MIL-PRF-39012D
AMENDMENT 3
16 July 2002
SUPERSEDING
AMENDMENT 2
7 July 1998

PERFORMANCE SPECIFICATION

CONNECTORS, COAXIAL, RADIO FREQUENCY
GENERAL SPECIFICATION FOR

This amendment forms a part of MIL-PRF-39012D, dated 13 July 1995,
and is approved for use by all Departments and Agencies of the Department of Defense.

Example:

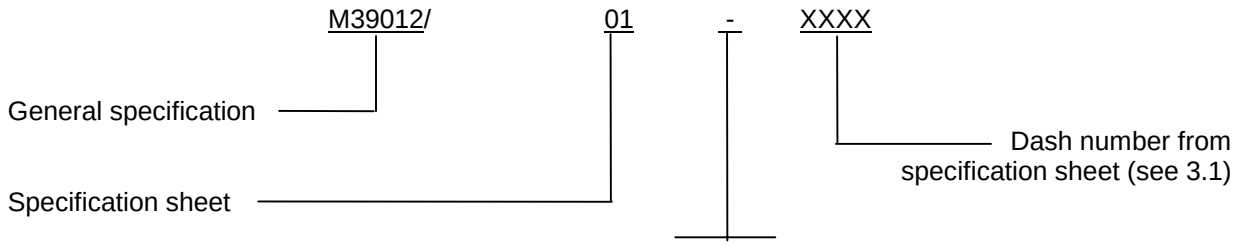
1.2.3 Part or Identifying Number (PIN). The PIN consists of the letter “M” followed by the basic specification sheet number, and a sequentially assigned four-digit dash number. The first digit in the dash number designates the material of the connector body (shell); i.e., “0” for brass, “3” for corrosion-resistant steel, or “4” for copper beryllium.

The “-“ designates a standard military part. This position, when filled with the letter ‘B’ (i.e. M39012/01BXXXX), signifies a military part, which is for OEM use only. The part is assembled to the cable with special tooling. Acquisition of this type part by any agency other than OEM’s is prohibited and will result in the substitution of the equivalent military replacement part (i.e., if “M39012/01BXXXX” is submitted for acquisition, “M39012/01-XXXX” will be recommended).
